Access Report

**Loxford Childcare Centre**  
464 Cessnock Road  
Gillieston Heights NSW 2321

For: Stevens Group  
Ref: PAA\_24055

Development application documentation for the proposed childcare centre located at 464 Cessnock Road, Gillieston Heights, has been reviewed against current accessibility legislation.

Figure 2 | Overall Site Plan

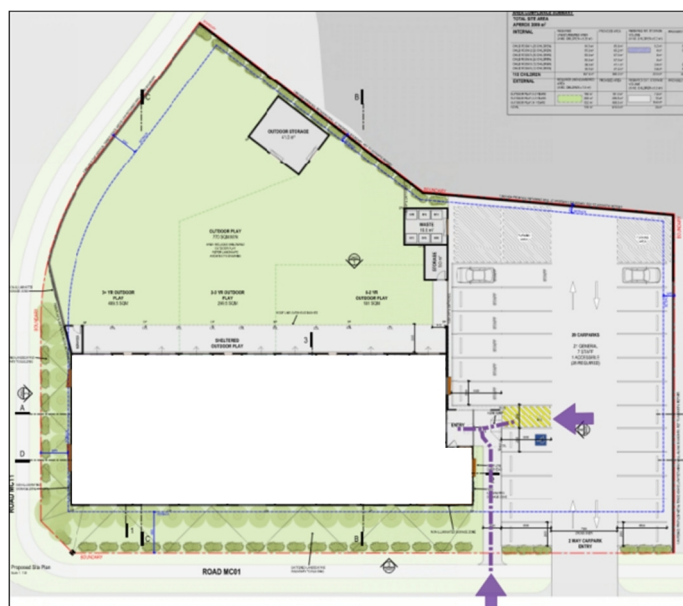
An accessible path of travel is provided to the building entrance from the allotment boundary along Cessnock Road via a formed footpath.

An accessible path of travel is provided to the building entrance via a formed footpath. A kerb ramp is provided along the approach to facilitate access.

Footpaths that form the approach to the building are dimensioned at least 2000mm wide. A level surface is achievable.

On grade parking is provided on the eastern side of the building. Plans note a total of twenty (29) carparking spaces, one (1) of which is nominated as an accessible space. It is located in close proximity to the building entrance.

The overall configuration of the accessible carparking achieves compliance with current legislation including dimensions of the space and associated shared areas, chevron markings and provision of a bollard.

Kerb ramp is provided along the path of travel from the accessible carpark to the building entrance.

A sliding door is provided for entrance to the building. A level threshold hold is achievable at the doorway.

A single hinged gate provides entry to the building and offer compliant circulation areas. Ensure that the selected door enables a clear opening width of 850mm.
